# Instructional Department Notes

## Gunnery Department

### COLLIMATOR

**Figure 1.**

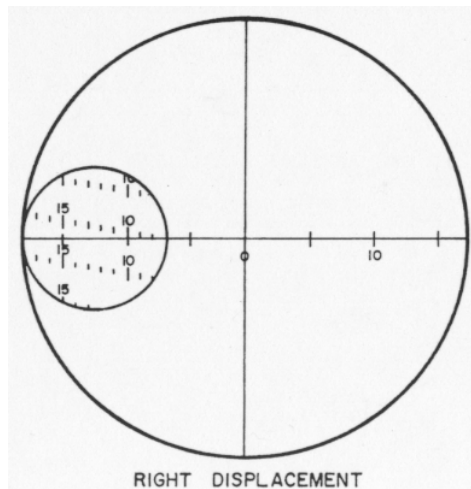
The following publications contain an error on the illustration showing collimator displacement. The illustrations, which show the correct alignment, were erroneously labeled left displacement when they should be labeled right displacement.

- \* **ARTILLERY TRENDS**, January 1967 issue, page 39.
- \* **Fire Control and Coordination Information Letter . . . . 2, M1 Collimator**, 18 February 1967, page 14.
- \* **Notes for the Battery Executive**, July 1967, page 17.
- \* **PS Magazine**, Issue 183, 1968 Series; page 10.

The correct labeling of the illustration is as shown below.

The US Army Artillery and Missile School is publishing a revised information letter on the M1 Collimator. This letter, entitled, "**Fire Control and Coordination Information Letter . . . 2 (Revised), M1 Collimator**", will correct the error in sight picture labeling, and give increased coverage on employment, to include use of the collimator in conjunction with aiming posts for a 6,400-mil capability.
